CHANGE ORDER NO. 14

PROJECT:	<u>Horizon City Municipal Facilities Phase I</u>	DATE OF ISSUANCE:	January 27, 2026
OWNER:	TOWN OF HORIZON CITY 14999 Darrington Rd. Horizon City, Texas 79928	EFFECTIVE DATE:	January 27, 2026
CONTRACTOR:	<u>Dantex General Contractors</u> <u>4727 Osborne</u> El Paso, TX 79922	ARCHITECT:	Eugenio Mesta, AIA Exigo Architects 211 N. Florence Ste. A El Paso, Tx 79912
CONTRACT FOR:	<i>New Municipal Facilities for the City of Horizon</i>	OWNER'S BID NO.	CSP 23-038 Project No. 2.513D
		ARCHITECT'S PROJECT NO:	20201600

TITLE: Additional Power and Data Drops per ASI #07

To: DANTEX Construction
From: Jesus Ortega, EXIGO Architects
Project: HCMF
Date: November 13, 2025
Re: **ASI 007 – New Power and Data request**

**SPECIAL
SYSTEMS PLAN
'A'
E4.0R3**

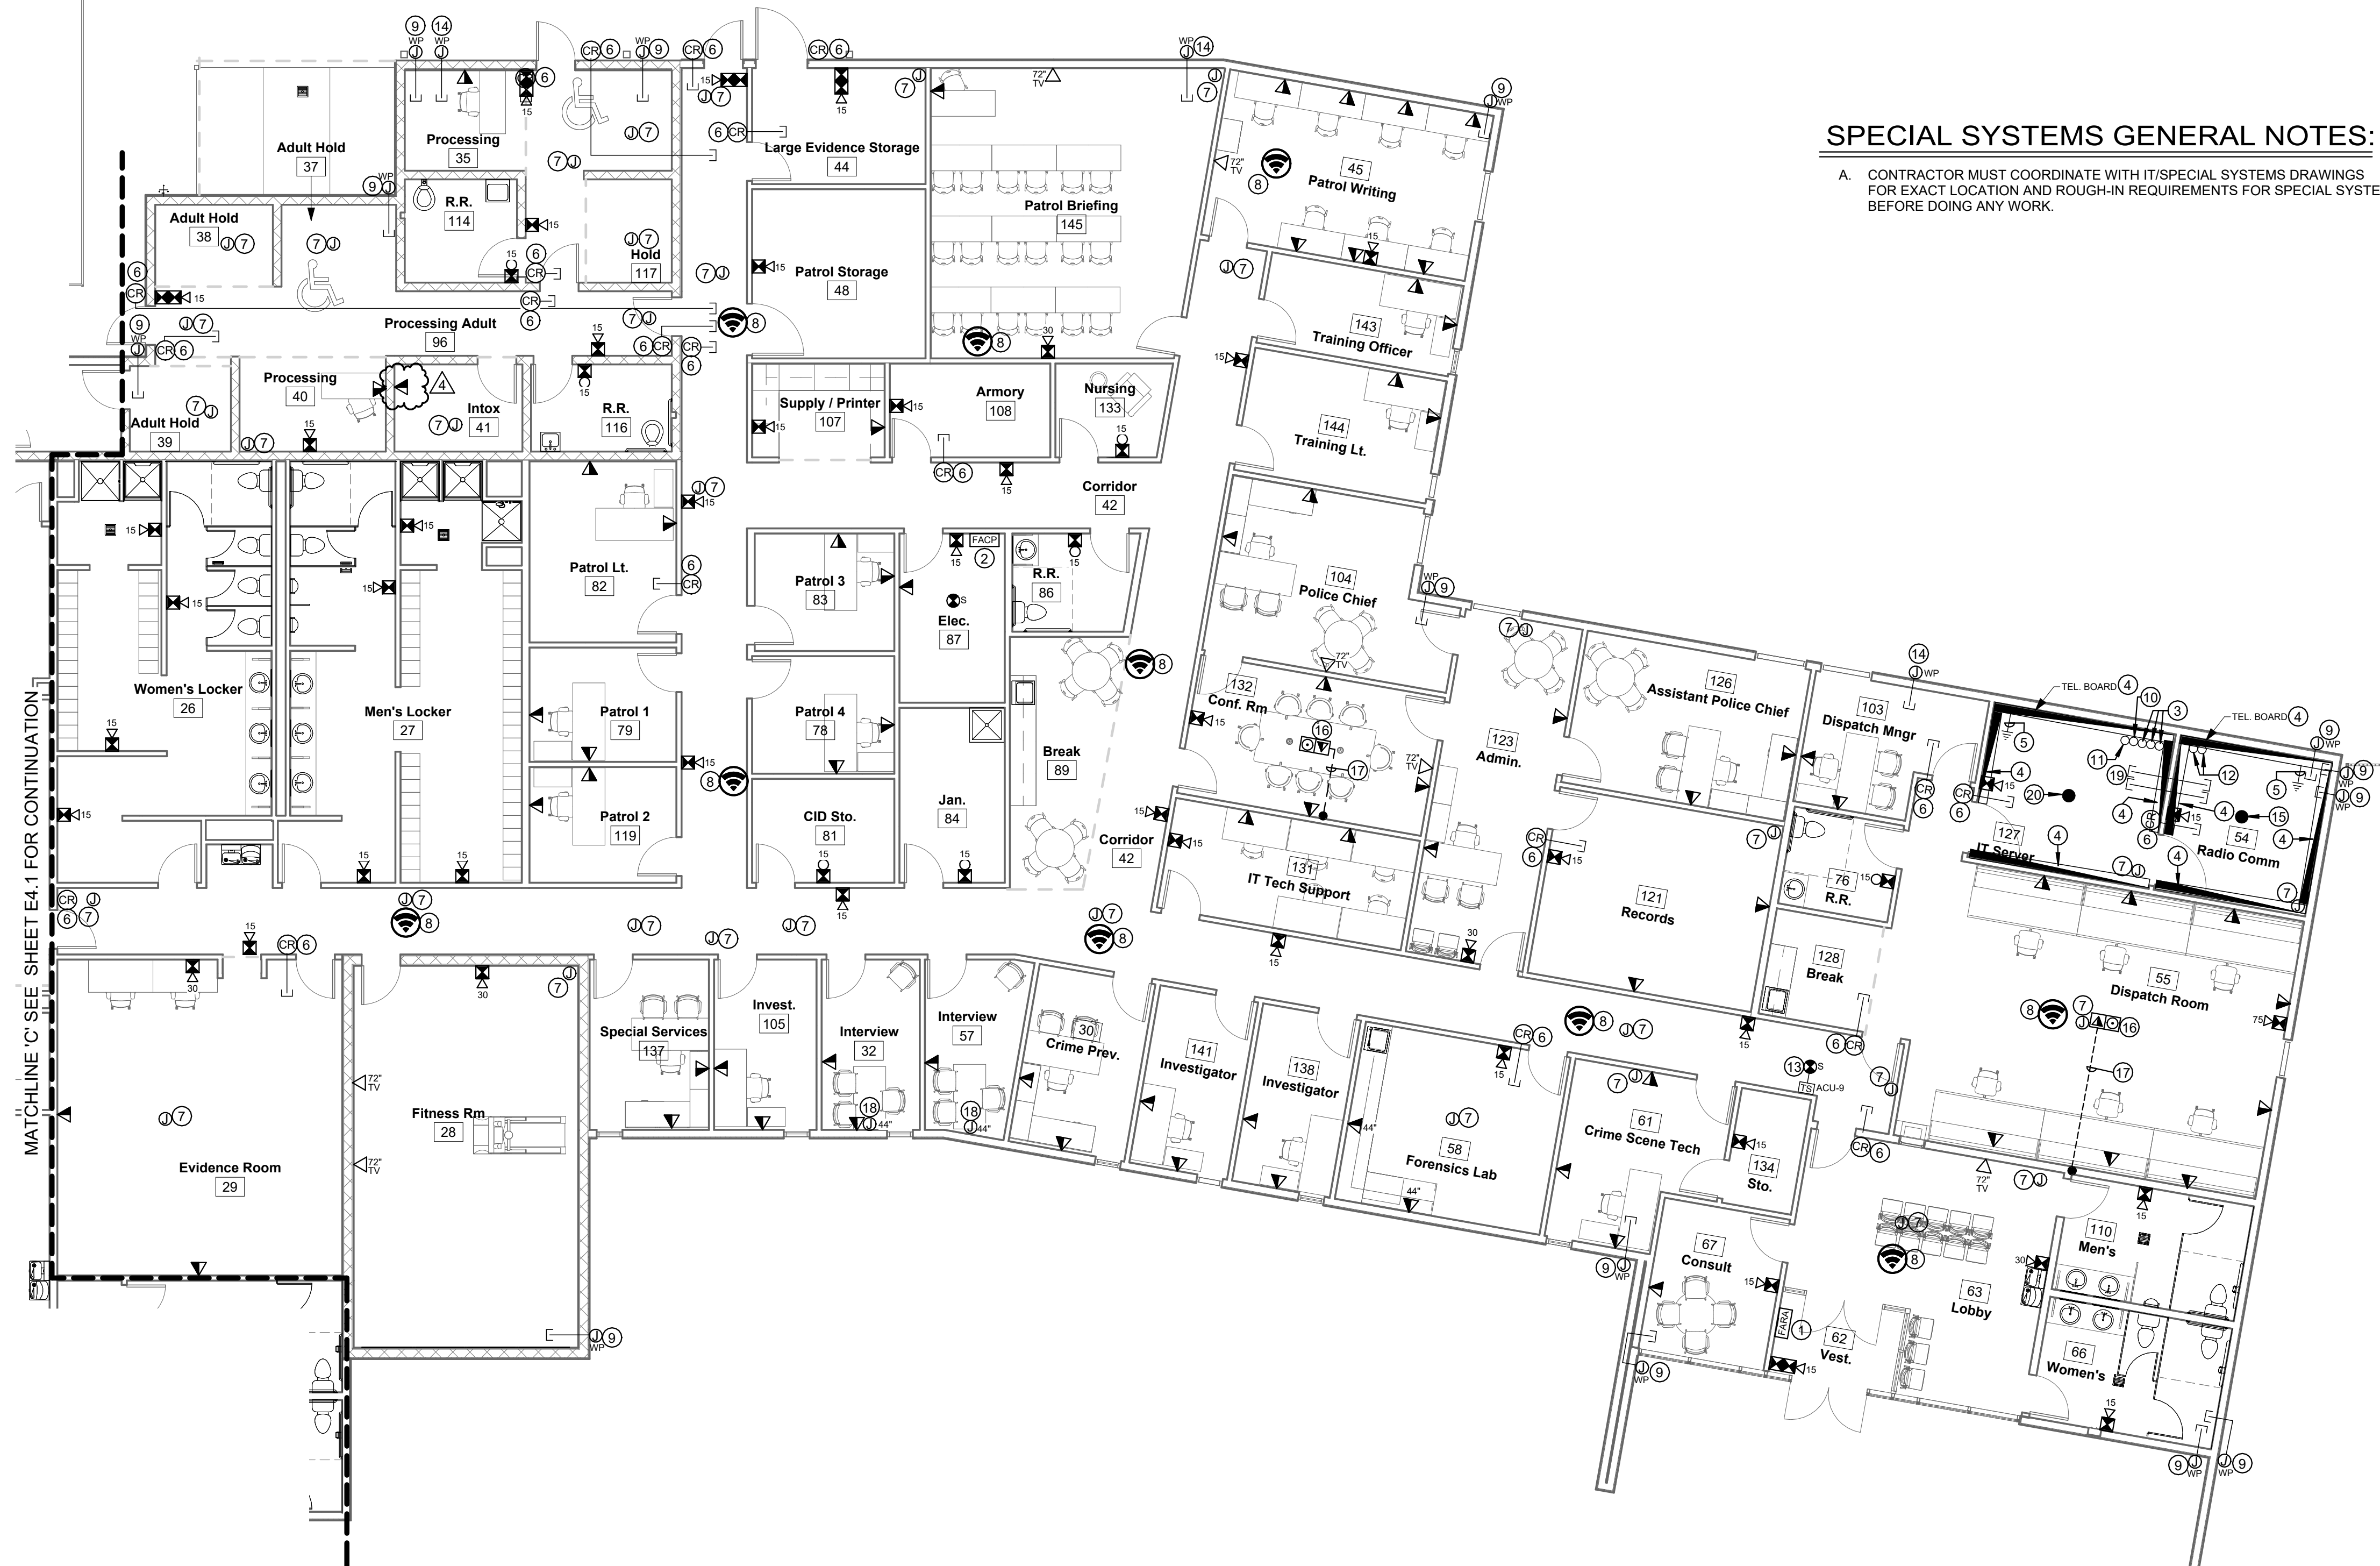
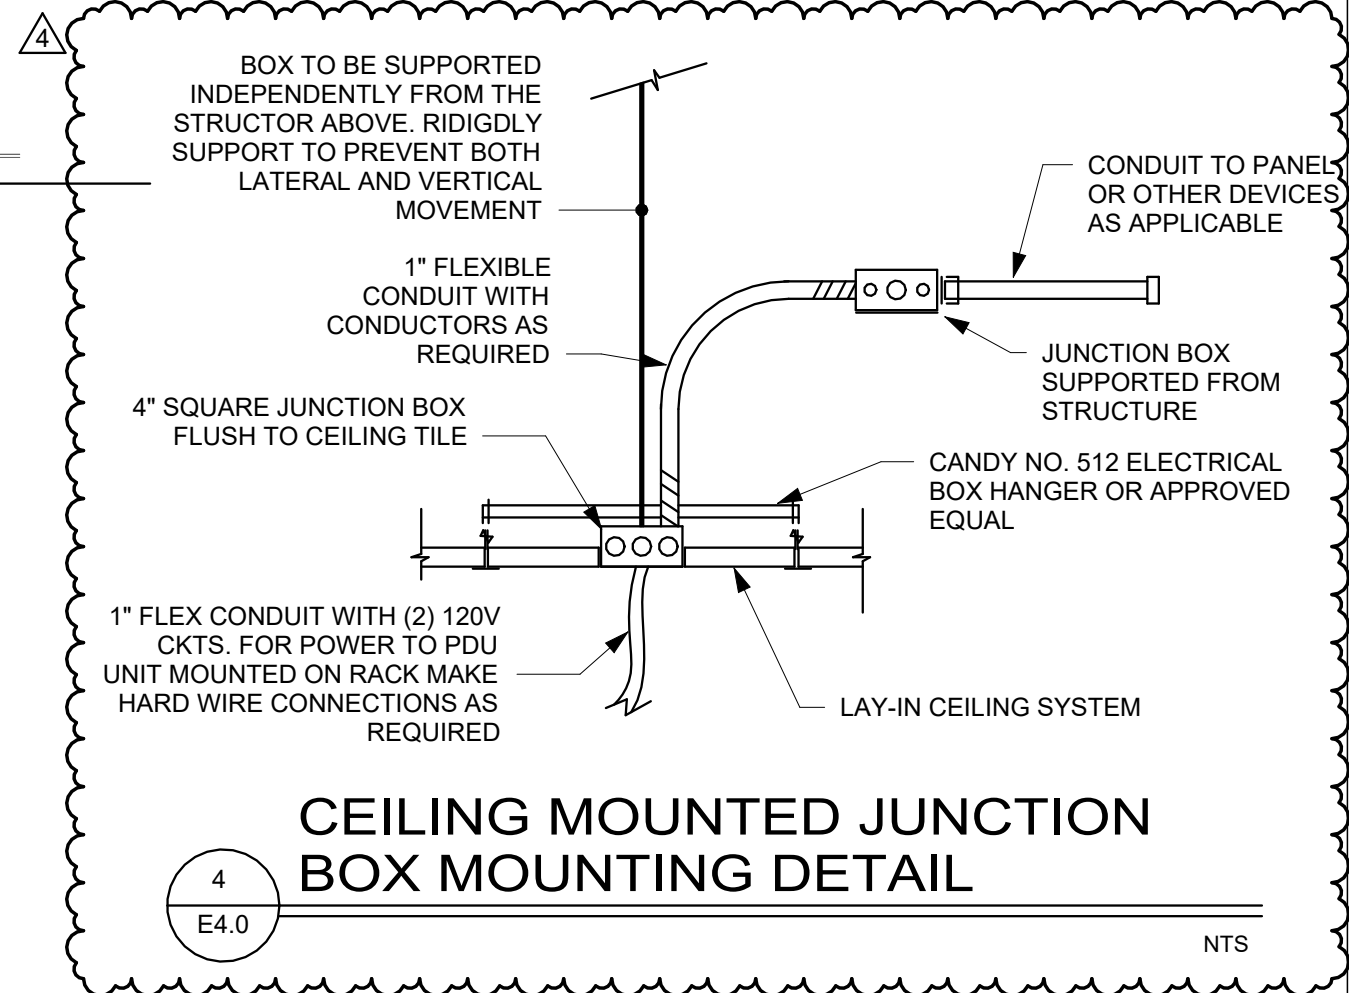
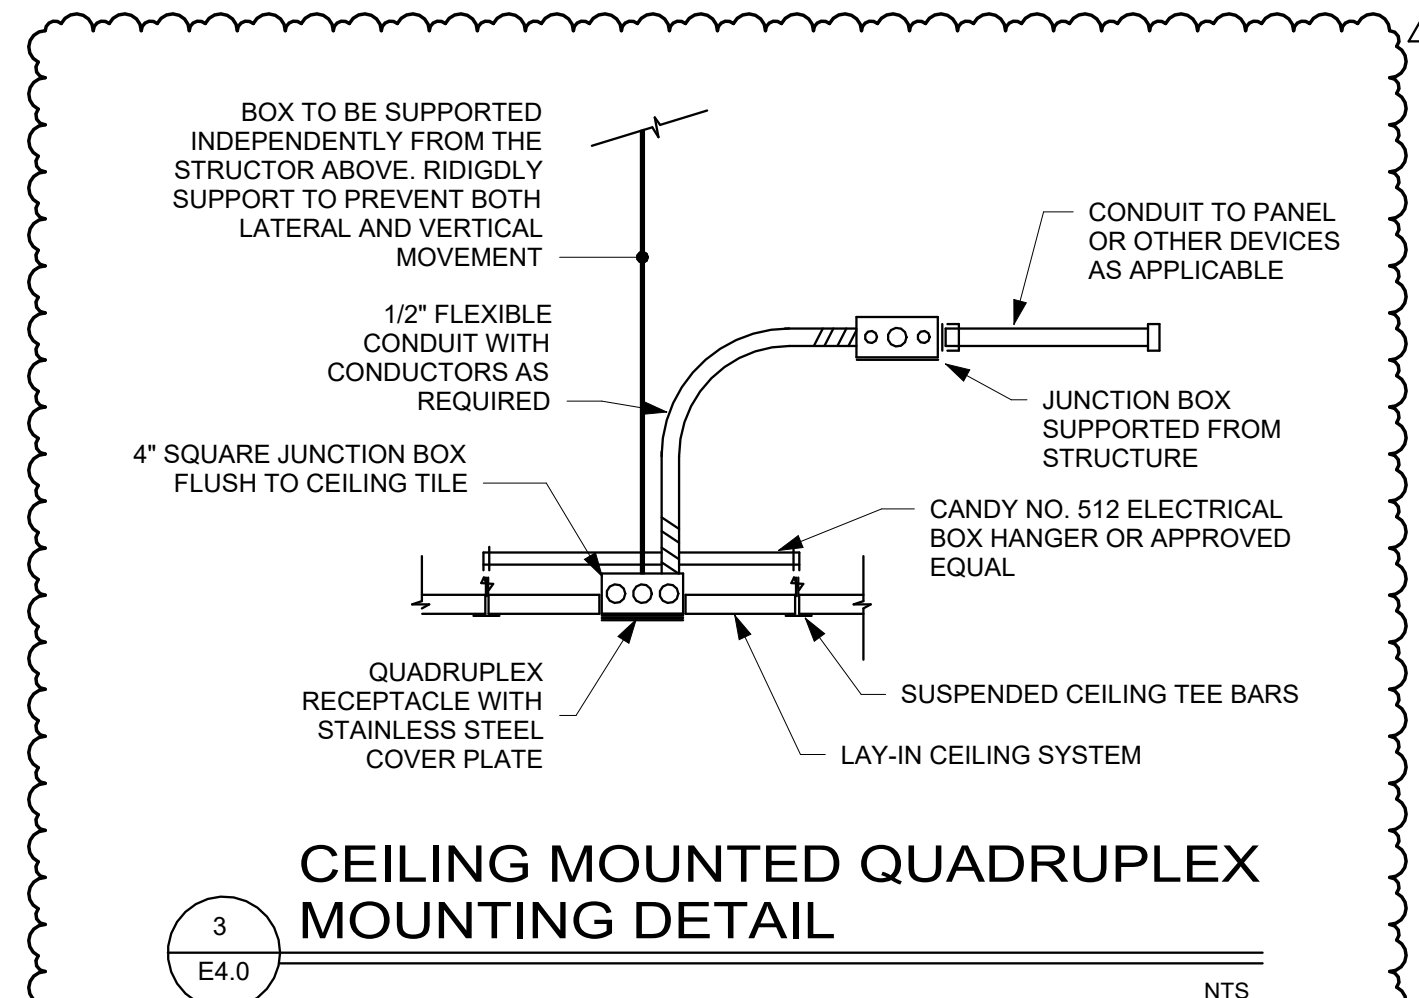
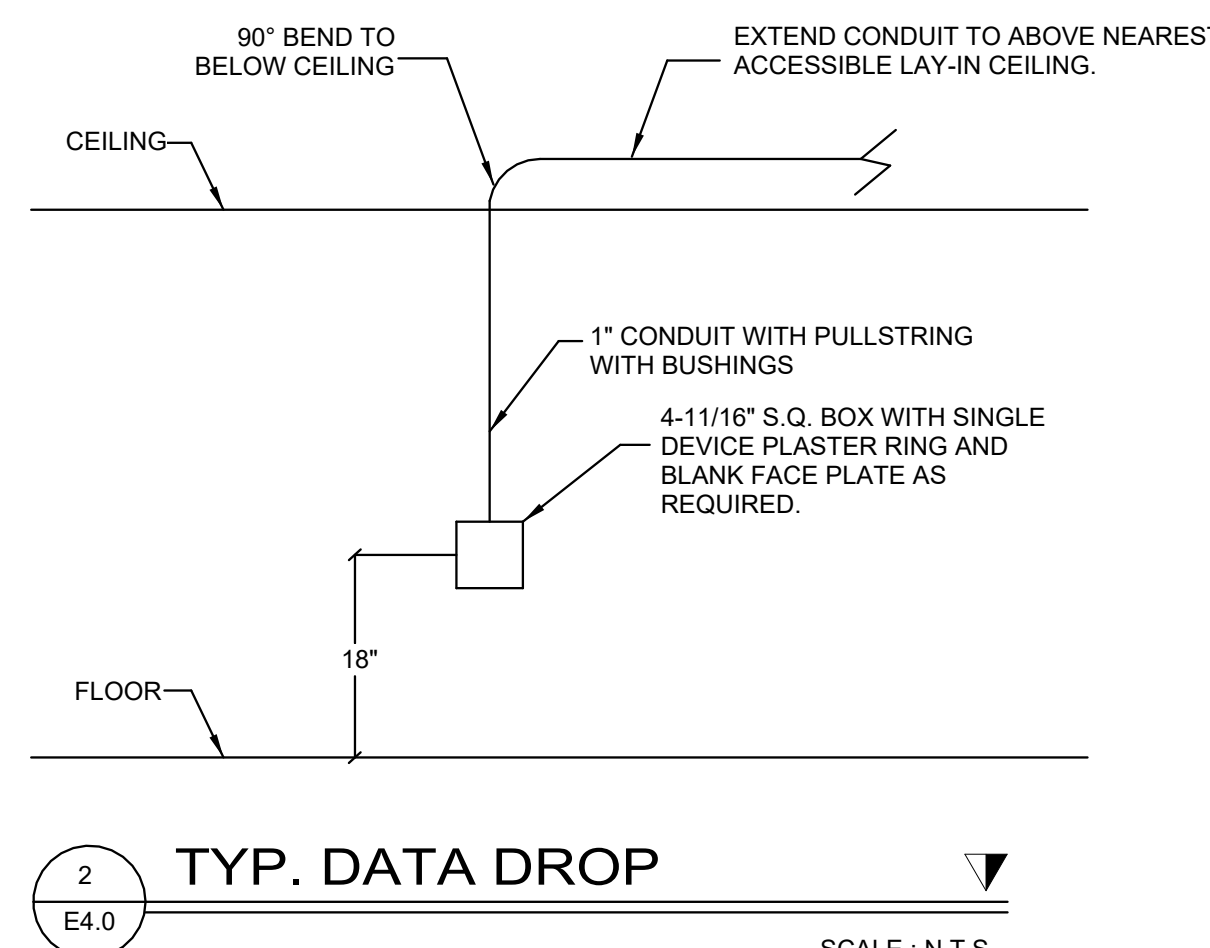
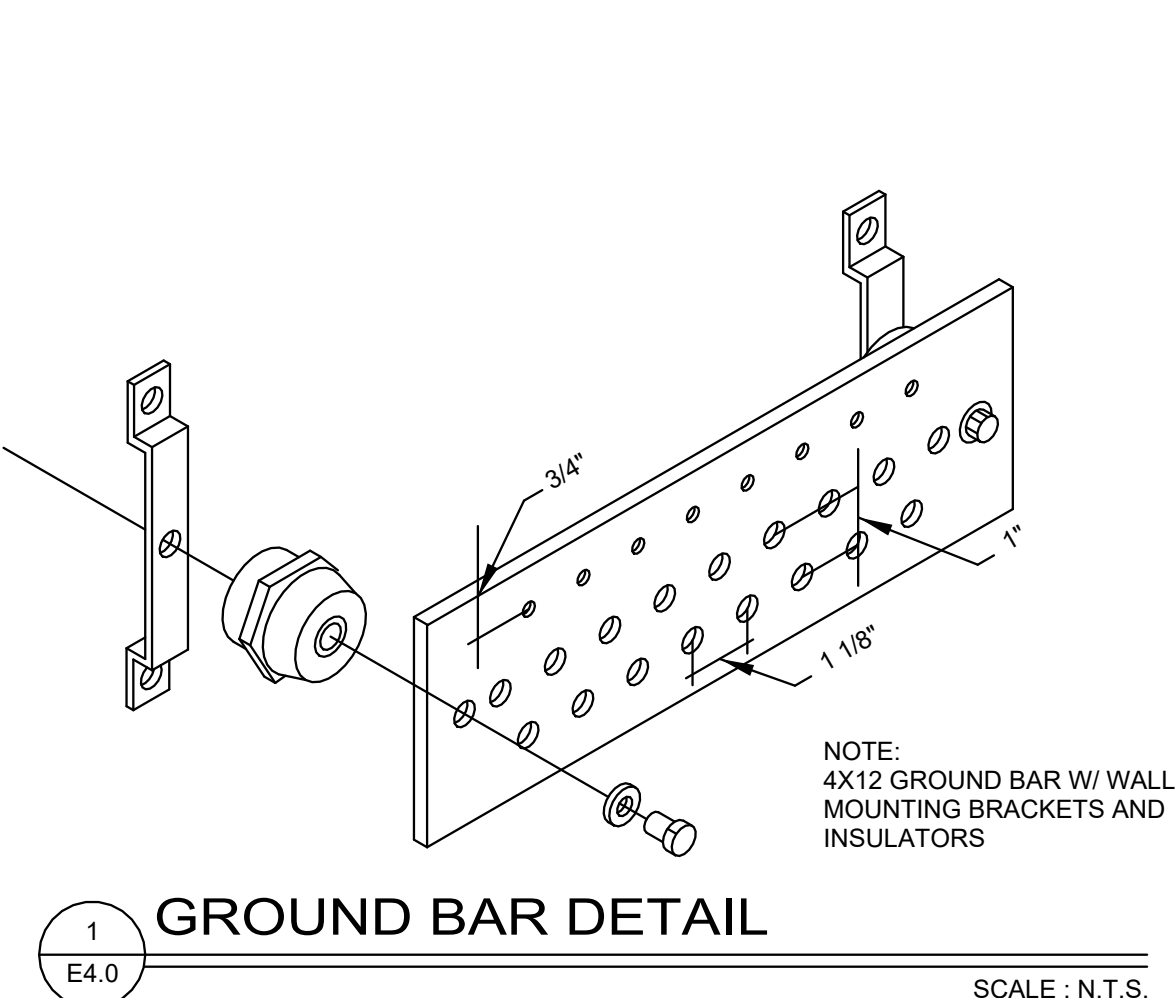
- a) ASI 007 – E3.0R2 – Delta#4: Power Plan “A”_
- b) ASI 007 – E4.0R3 – Delta#4: Special Systems “A”
- c) ASI 007 – E4.1R1 – Delta#4: Special Systems Plan “B”
- d) ASI 007 – E6.0R2 – Delta#4: Panel Schedules
- e) ASI 007 – E6.1R1 – Delta#4: Panel Schedules
